HISTORIC DISTRICT COMMISSION

Application for *AMENDMENT*

Property address/location: 1 Madbury Rd Tax map and lot #: 4-1
 Name of project (if applicable): BALLANS BUILDING EXPANSION

1. NORTHEAST (MADBURY ROAD) ELEVATION
 Scale: 1/8" = 1'

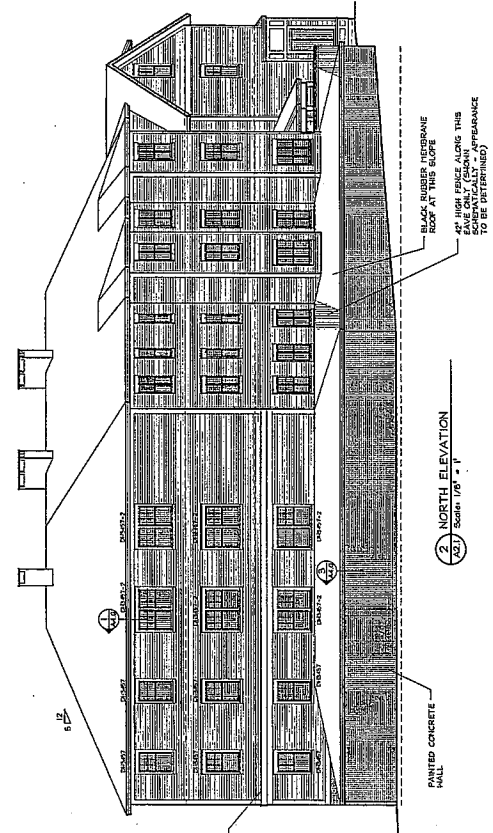
A – Try adding an eave/architrave to form a pediment (triangle) at the top.

B - Try adding a small pediment onto a few of the windows. On the block on the right these might be better over the outer 2 rather than the inner 2 windows

C – Try making these cornerboards wider. This should probably also include the cornerboard of the main building at the far left.

D – Try putting in double windows here to match the ones above.

E – What will this metal look like? Will it be solid?

F – I think the posts should be jazzed up a little. I saw an earlier drawing that had a taller base/pedestal that looked good. I think there should be stronger capitals also.

G – For all the places where a vertical meets a horizontal (including windows and architraves), like this, can you show the vertical supporting the horizontal like the little detail I put next to G? You may already have this in your details.

H – How about a little detail here to jazz up the building a little, like a diamond shaped lozenge?

I – I think double windows would be better here (oops, no J)

K – For all the double windows please include a wide mullion in the middle, at least as wide as (and preferably wider than) the outer vertical trim so that it does not look like two windows are mashed together.

L – Can you add a frieze board here?

M – Can you enrich the lintels here a little to help jazz up the façade a little?

N – I think another diamond lozenge would look good here

O – How about putting in a horizontal mullion all across. A lot of storefront windows have this to add some form. If you do please make it a real mullion (not a fake bar sandwiched in the glass) so that all of the windows are separate.

P – How about adding dentils like on the Grange? This might look good or it might look overdone.

Q – The vertical panels look just a little too...vertical. How about putting two small horizontal panels instead. See the little detail next to Q.

R – How about adding another chimney here? This would balance out the other three.

S – Try adding a horizontal frieze board like on the other block on the far left of the East elevation.

T – Another diamond lozenge would look good here. Also, how about adding another window in the middle on the first floor? The façade is a little thin.

- I would encourage you to use brick or thin brick for the garage walls rather than a fake veneer. Could I see a sample of what you have in mind?

This will not be done but they will mimic the gable end of the exiting Ballard building. The Hip roofs on the back will be changed to gable roofs to match the front.

Put the same lintels/crowns that are on the Ballard House over the single windows on the Madbury Road side and on the 4 second floor windows on the Main Street side.

Cornerboards at building corners will be 8” and at bays 6”

This will be done.

This will be black iron or steel

You will look at doing more substantial “columns” rather than Victorian-type “posts”. See attached.

This will be done.

This will NOT be done.

You will put the downspout here which will break it up a little

This is will be done.

This is will be done.

This will be done, per B above.

This is will NOT be done.

This is will be done.

This will NOT be done.

We discussed installing 4 gooseneck type lights here

This will NOT be done.

This will be done.

This will NOT be done.

You will use thin brick (which is a real brick)

4 ENLARGED VIEW OF GARAGE OPENINGS
 Scale: 1/4" = 1'

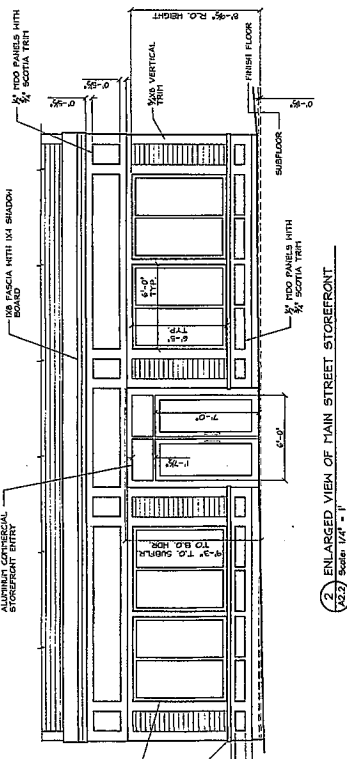
There will be a thicker lintel across the garage opening, which might extend across the entire block here.

This will be done.
